Access Audit Site Report

Devils River State Natural Area - Dan A. Hughes Un

Accessibility Evaluation

**TEXAS PARKS AND WILDLIFE DEPARTMENT
DEVILS RIVER STATE NATURAL AREA - DAN A. HUGHES UNIT**

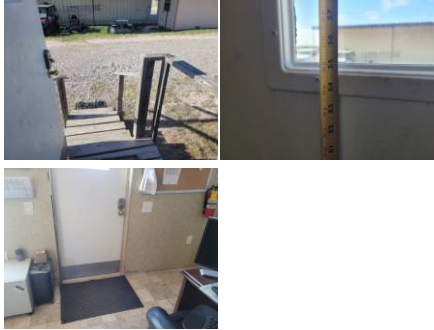
Finding Number	Area Description	Lat/Long	Finding	As Built	Recommendation	Citation	Photos	Figure
5	Administration Building: Admin - Parking	[29.73748, -100.9635]	The surfaces of the accessible parking spaces and access aisles are not firm, stable, and slip resistant. Floor and ground surfaces shall be stable, firm, and slip resistant. Parking spaces and access aisles serving them shall comply with 302. Access aisles shall be at the same level as the parking spaces they serve. Changes in level are not permitted.	Gravel parking area (approximately room for 10 total spaces), gravel to all buildings except lodging	Create one or more 8' accessible parking stalls, with one 8' adjacent access aisle, with proper signage and striping on a firm and stable surface.	2015 ABAAS Section: 502.4, 302.1 2012 TAS Section: 502.4, 302.1 2010 ADAS Section: 502.4, 302.1		
6	Administration Building: Admin - Public Spaces	[29.7375, -100.9635]	Minimum maneuvering clearances at doors and gates shall comply with 404.2.4. Maneuvering clearances shall extend the full width of the doorway and the required latch side or hinge side clearance. Maneuvering clearances shall have a max slope of 2.08%. Door openings shall provide a clear width of 32 inches (815 mm) minimum. Clear openings of doorways with swinging doors shall be measured between the face of the door and the stop, with the door open 90 degrees. Openings more than 24 inches (610 mm) deep shall provide a clear opening of 36 inches (915 mm) minimum. There shall be no projections into the required clear opening width lower than 34 inches (865 mm) above the finish floor or ground. Projections into the clear opening width between 34 inches (865 mm) and 80 inches (2030 mm) above the finish floor or ground shall not exceed 4 inches (100 mm). The threshold at a doorway shall be no higher than 1/2 inch. Changes in level between 1/4 inch and 1/2 inch must be beveled at 1:2 or less. 1/4 inch is the maximum vertical rise.	Volunteer/staff lodging door - bed in pull side clearance, 29.5" wide, ramp up to door, large threshold	For all doors along the public circulation route, provide required maneuvering clearance on push and pull side of doors. For all doors along the public circulation route, replace doors with doors having 80" overhead clearance and 32" clear width. For all doors along the public circulation route, provide beveled threshold.	2010 ADAS Section: 404.2.3, 404.2.7, 404.2.4, 404.2.11, 404.2.11 Exception
